**Product Update: Front Balancer Shaft Oil Seal**
(Supersedes 00-073, dated November 2000)**BACKGROUND**

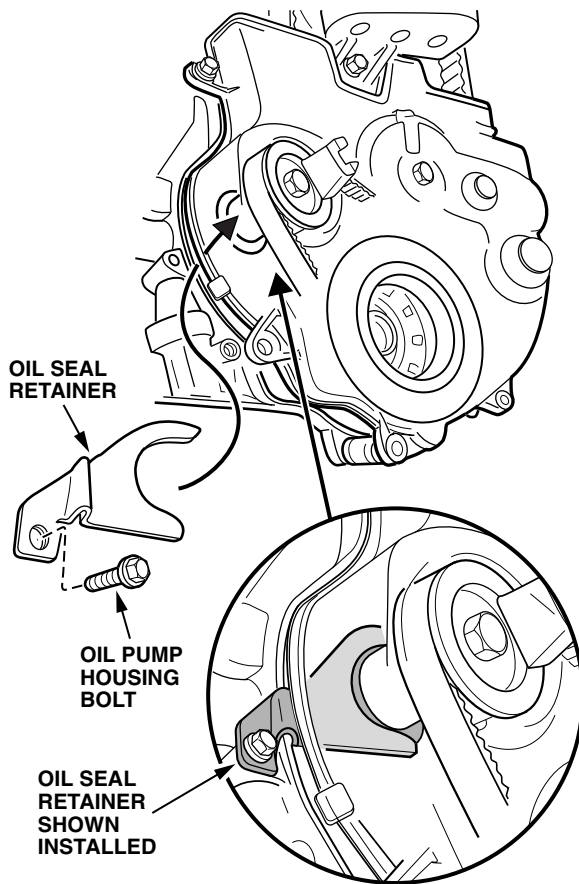
- Remove the oil pump housing bolt to the left and below the front balancer shaft.

- Install the oil seal retainer from the kit on the pump housing with the bolt you just removed. Torque the bolt to 12 N·m.
- Reinstall the lower cover bolts, making sure the rubber seal seats properly in the cover. Torque the bolts to 12 N·m.
- Reinstall the crankshaft pulley. Use the special tools and a torque wrench to torque the pulley bolt to 245 N·m. Make sure you use a torque wrench; do *not* use an impact wrench.
- Reinstall the splash shield mounting bolts. Torque the bolts to 12 N·m.
- Reinstall the left front wheel. Torque the wheel nuts to 108 N·m.
- Reinstall the dipstick tube with the new O-ring from the kit. Torque the bolt to 12 N·m. Reinstall the dipstick.
- DOHC Prelude only:* Reinstall the power steering reservoir and the power steering pump.
- Reinstall the alternator belt and the power steering pump belt.
